WASHINGTON DULLES INTERNATIONAL AIRPORT
NORTH FLANK PARKING GARAGE
Loudoun County, Virginia

Report to the Metropolitan Washington Airports Authority

March 4, 1999

PARKING GARAGE ELEVATIONS

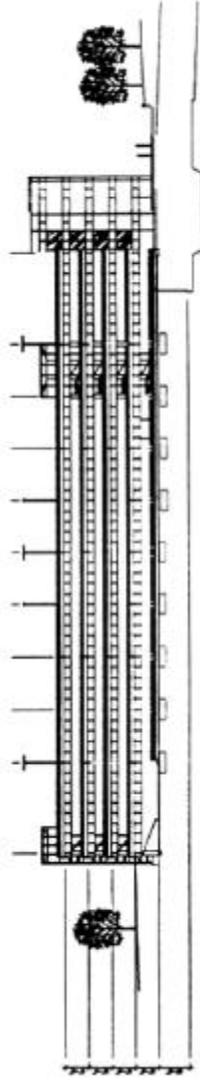
- The appearance of the parking garage is intentionally uncomplicated to remain subordinate to the Main Terminal.
- The building height is approximately 45 feet.
- The structure is cast-in-place post-tensioned concrete with precast concrete spandrel panels. The finish of the panels is similar to the color and texture of the concrete of the Main Terminal.

The proposed parking garage and associated landscaping will not obstruct any existing views to the Main Terminal from the Dulles Access Highway. The dense evergreen grid will significantly screen views of the parking garage from the access highway, while reinforcing the approach sequence in which the Main Terminal is visible from a distance, then hidden, then revealed again in full splendor.
